MIXED USE RESIDENTIAL FLAT BUILDING
 256-258 Victoria Rd,
 Gladesville, NSW 2111

Drawing Title
**GENERAL ARRANGEMENT PLANS
 BASEMENT 1 & 2 GAP**

Project Number	Drawing Number	Revision
21-018	S4.55-101	B
Status	S4.55 APPLICATION

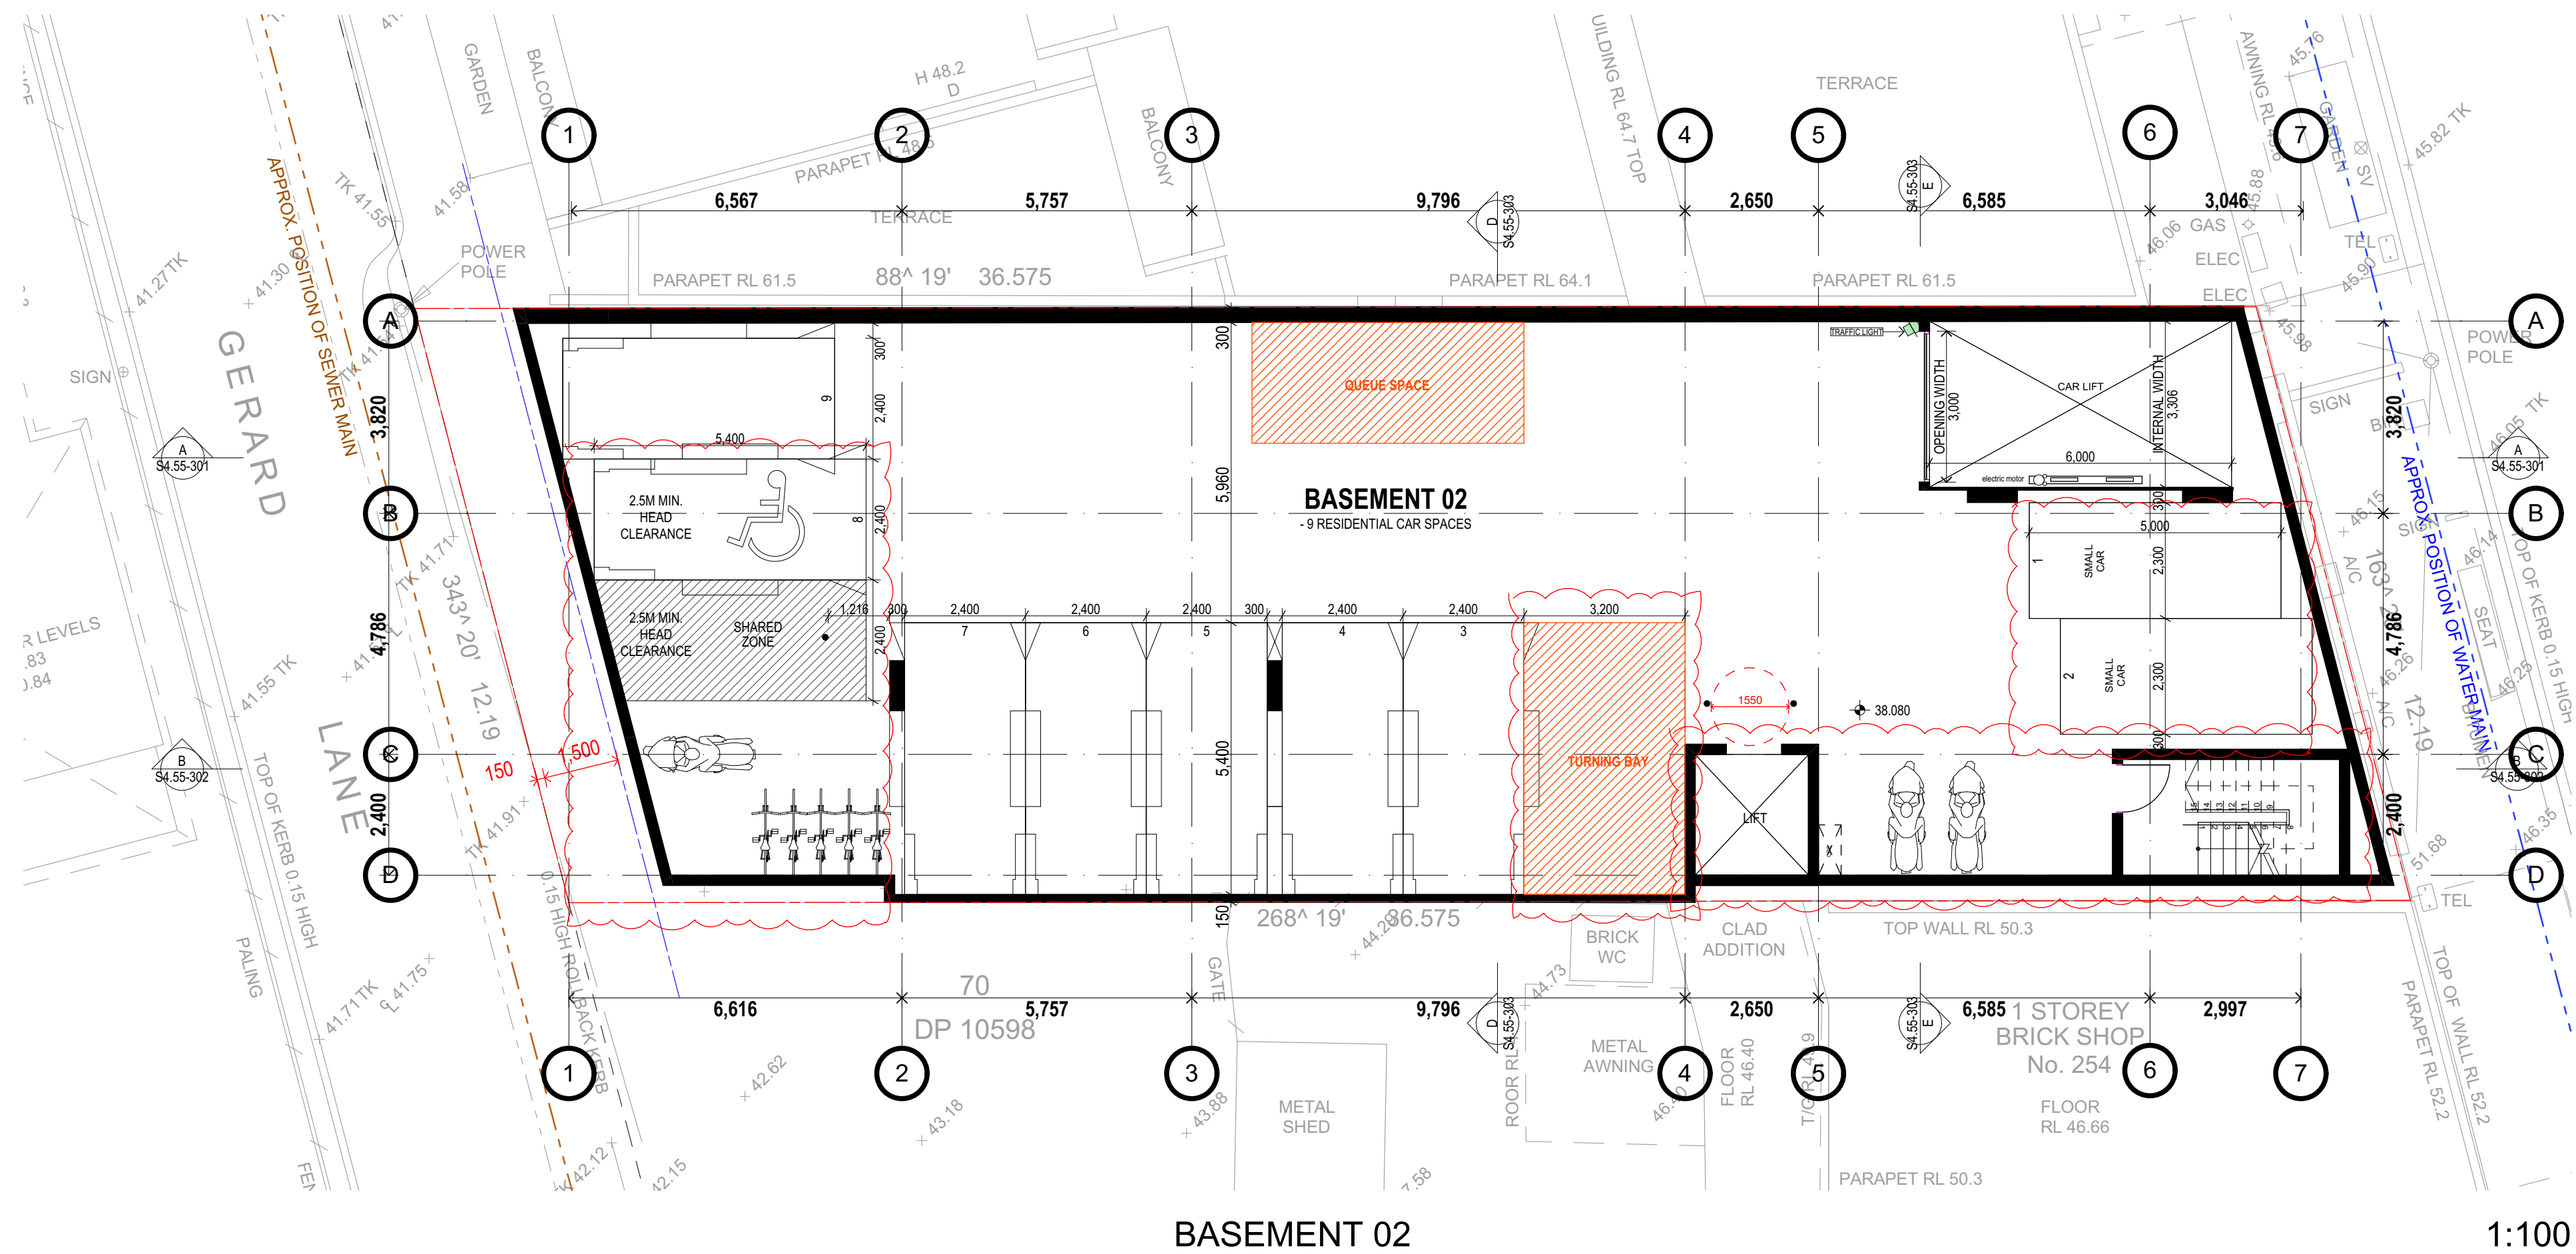
SCHEDULE OF AMENDMENTS BASEMENT 02:

- 2 car spaces changed to small car
- Turning bay added
- Fire stair enclosed for compliance
- Bicycles relocated

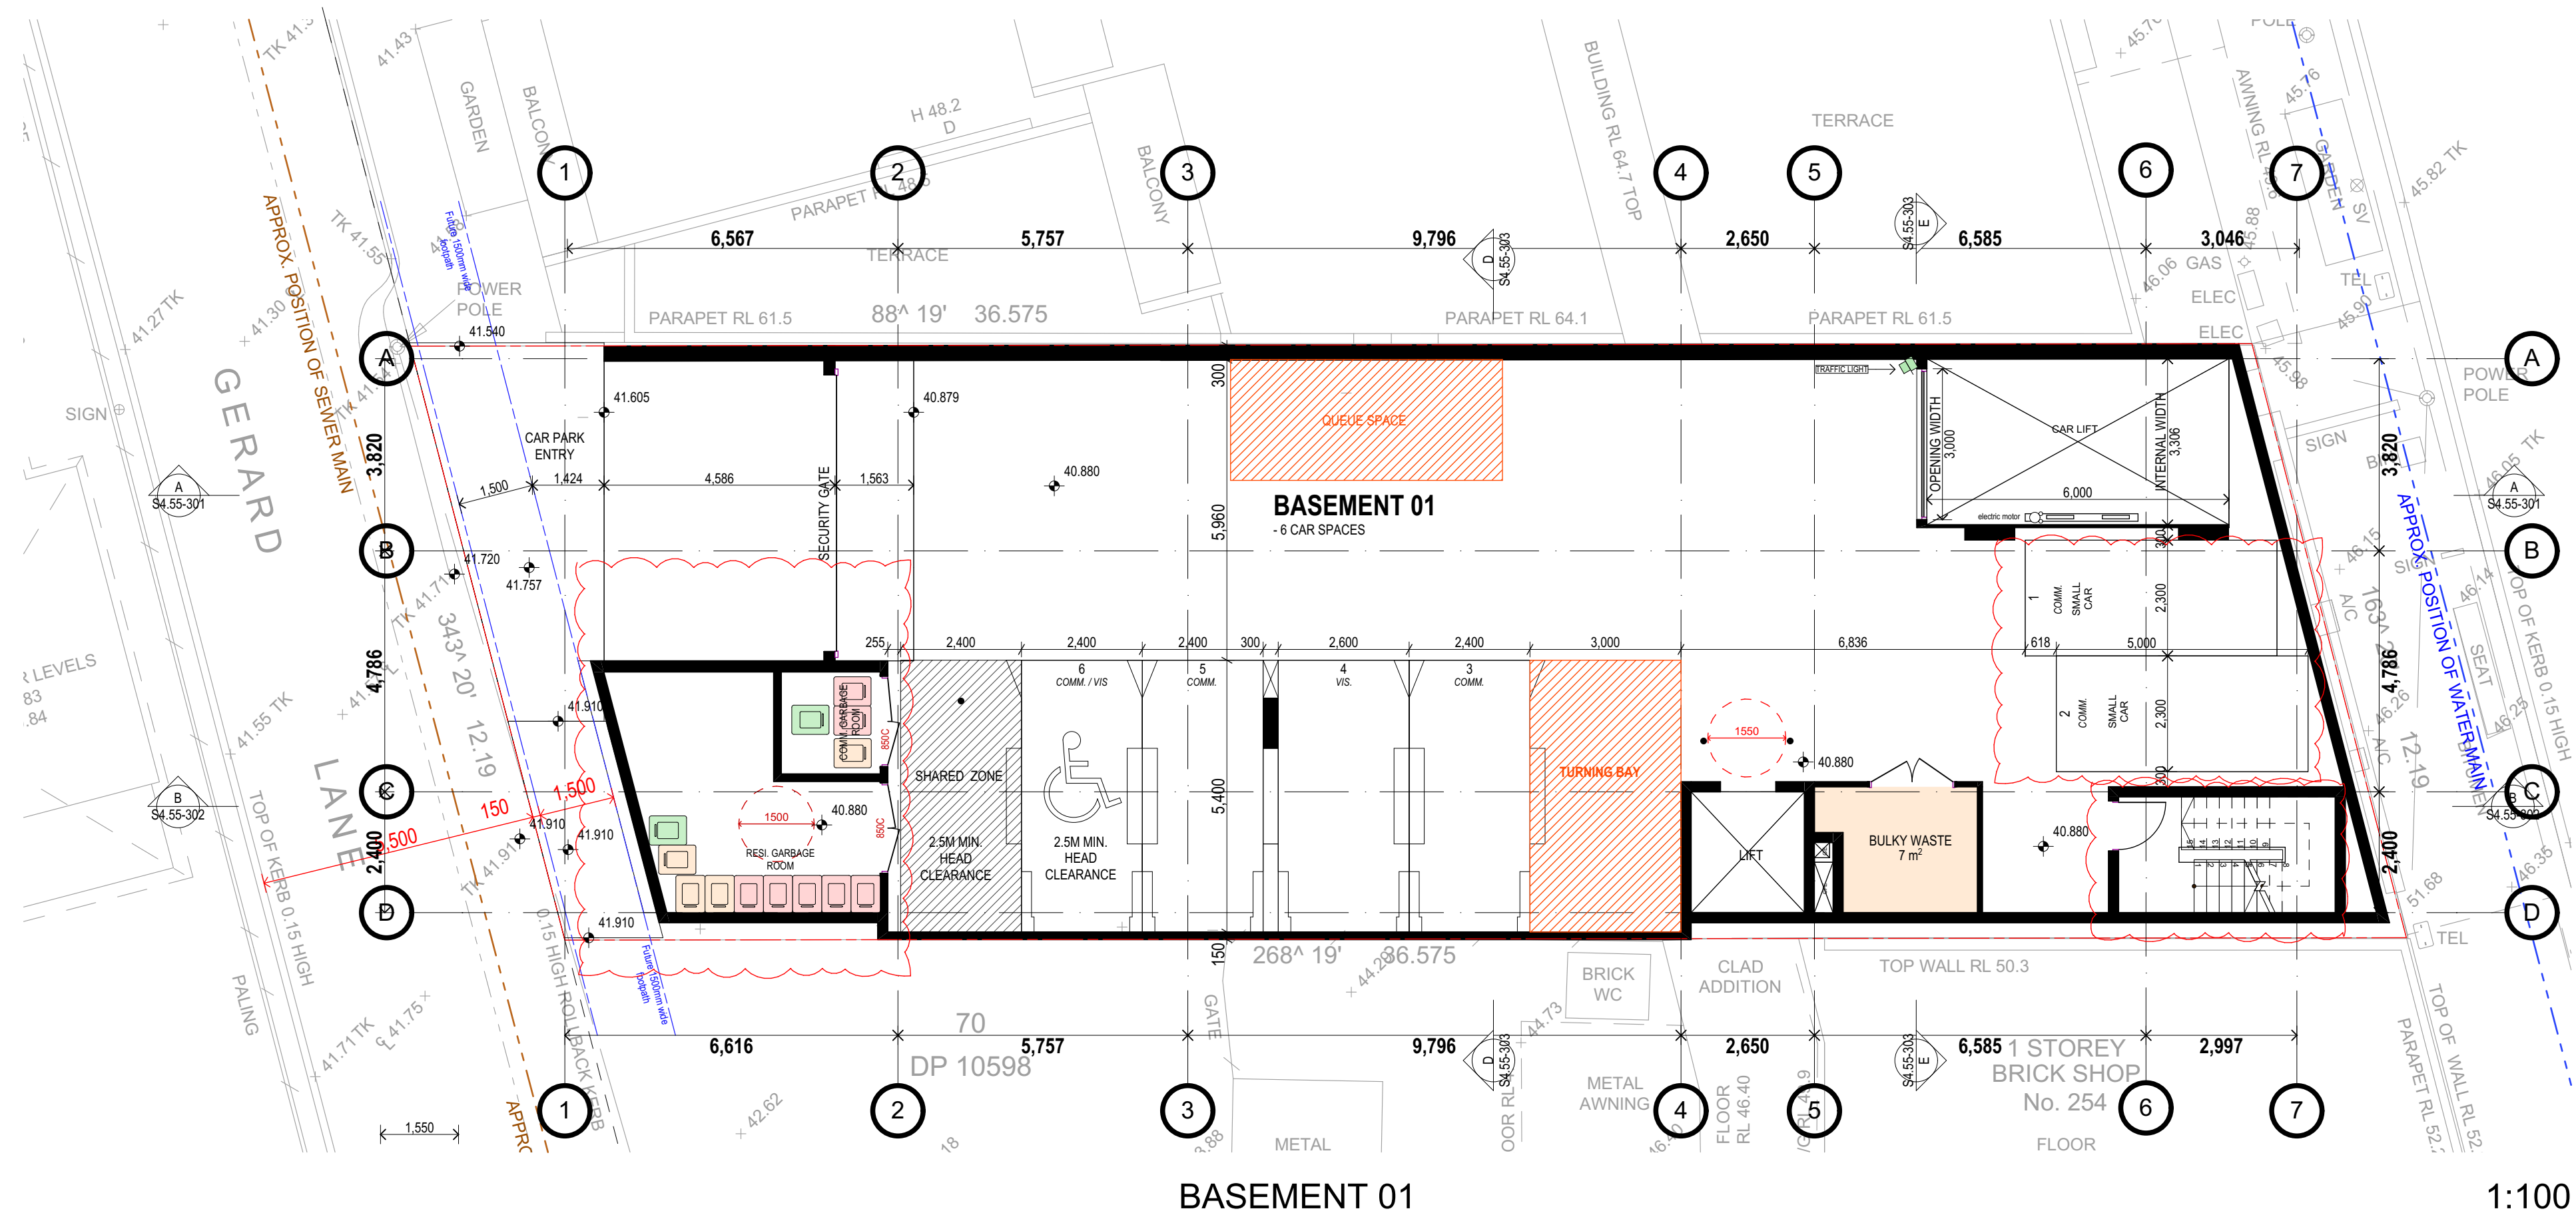
SCHEDULE OF AMENDMENTS BASEMENT 01:

- 2 car spaces changed to small car
- Turning bay added
- Waste room amended
- Fire stair enclosed for compliance
- Services added

Drawing Title
**GENERAL ARRANGEMENT PLANS
 LOWER GROUND & GROUND
 FLOOR GAP**

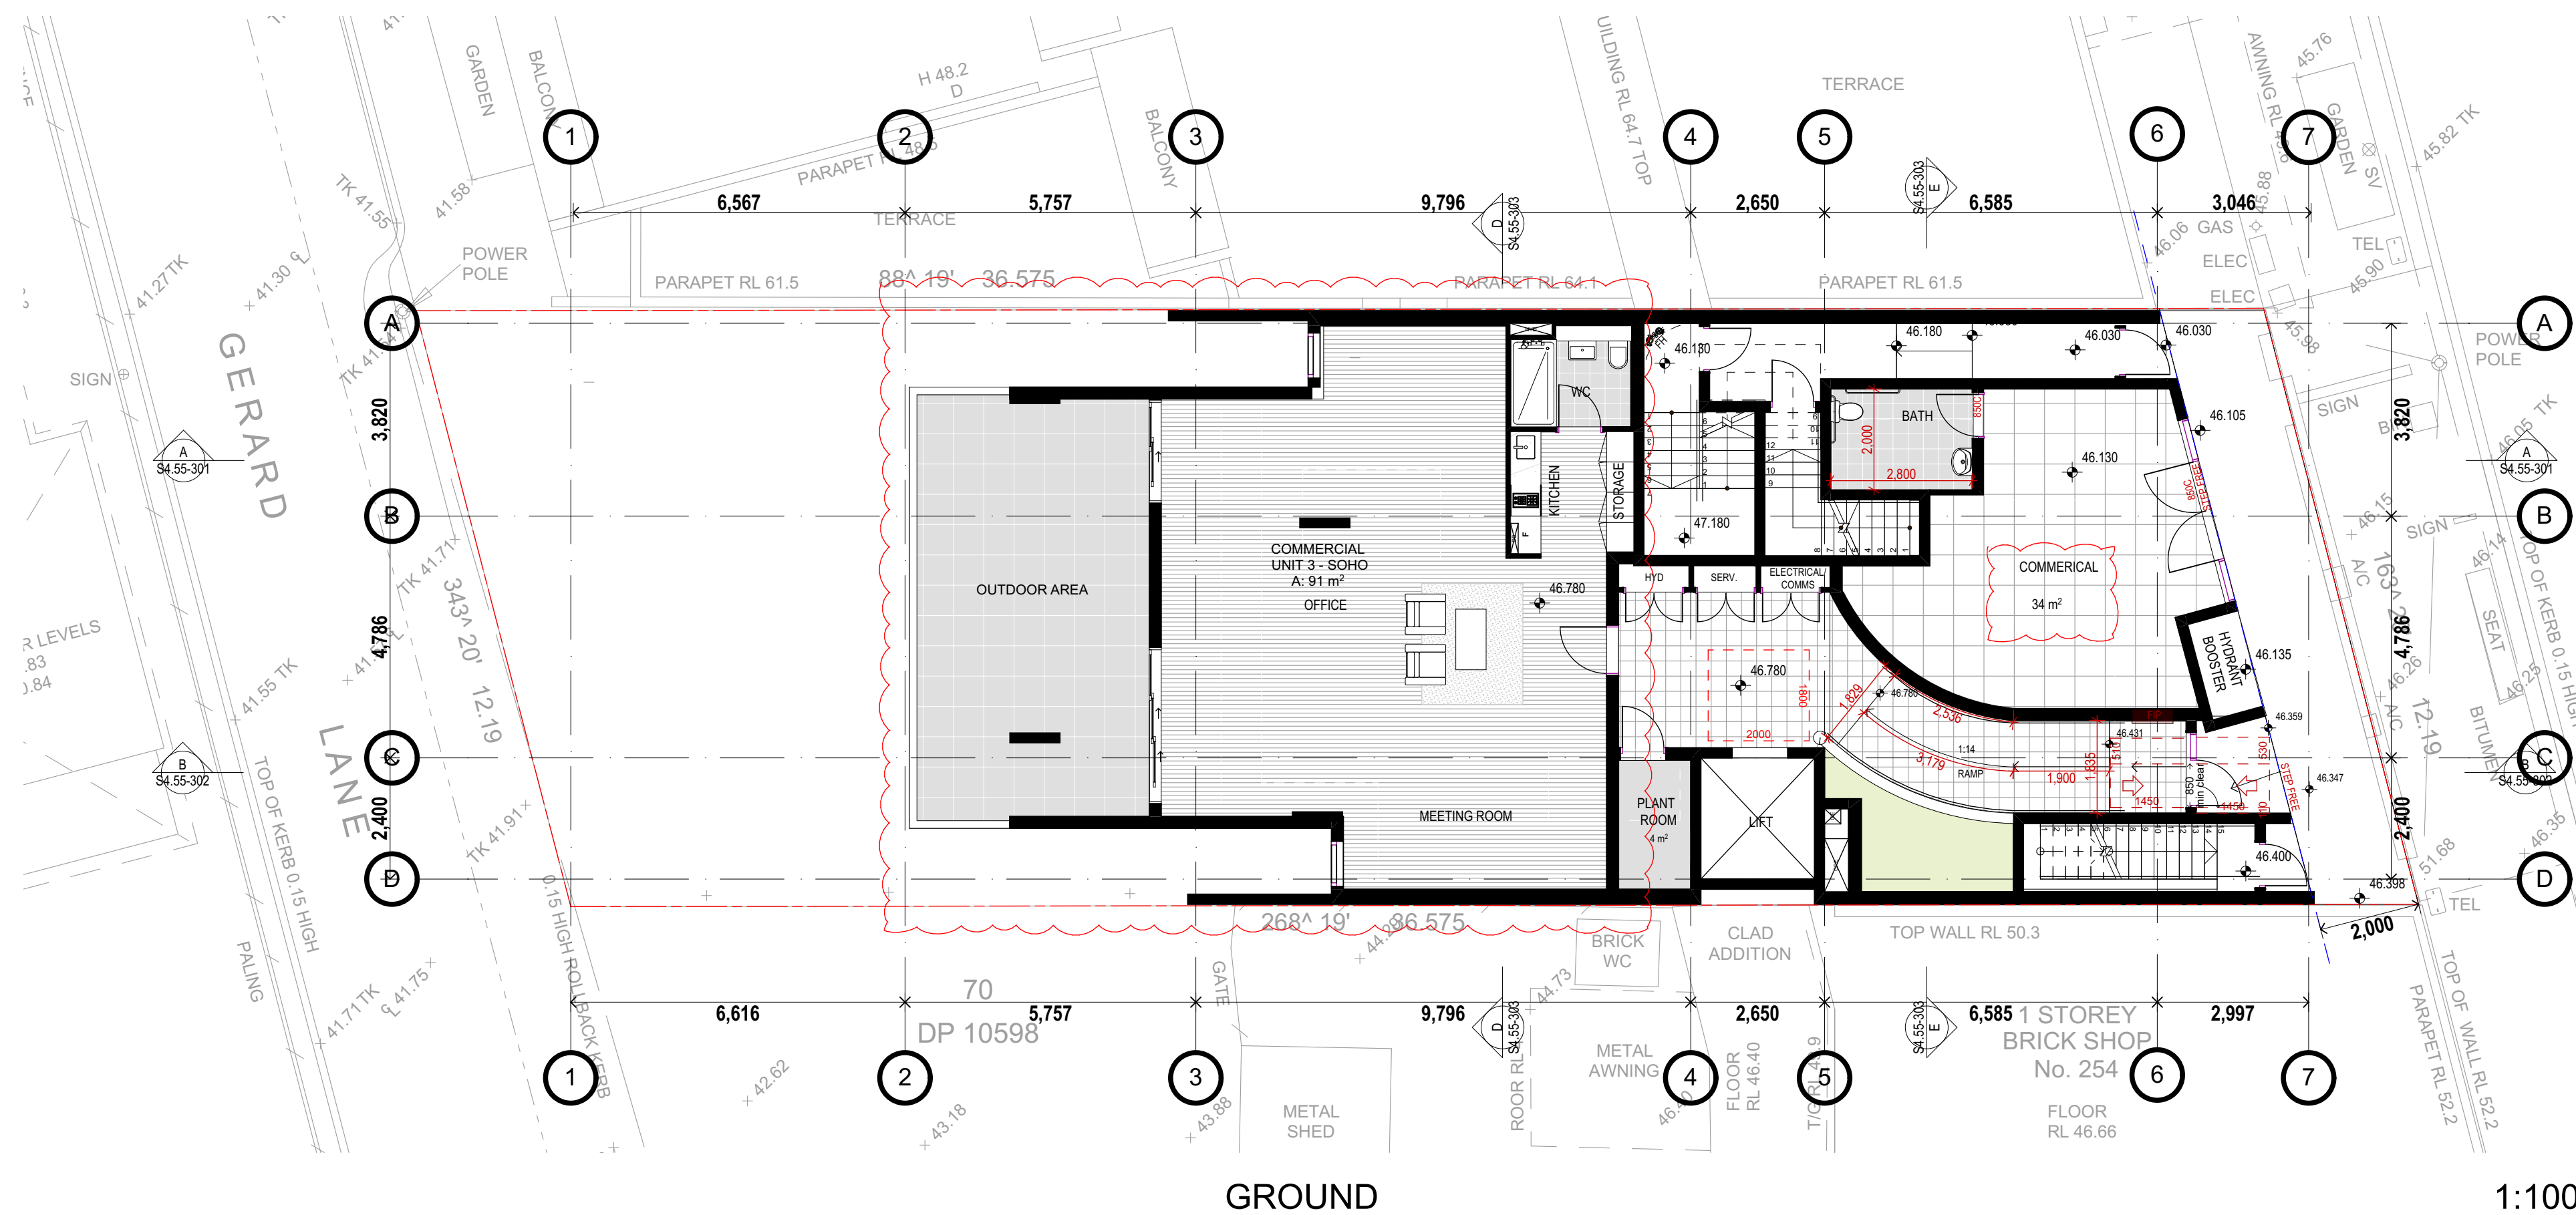
SCHEDULE OF AMENDMENTS LOWER GROUND:

- Kitchen/Living reconfigured
- General layout amendments
- Landscaped planter increased setback
- Services added

SCHEDULE OF AMENDMENTS GROUND:

- U-03 converted to an office
- Commercial tenancy size reduced
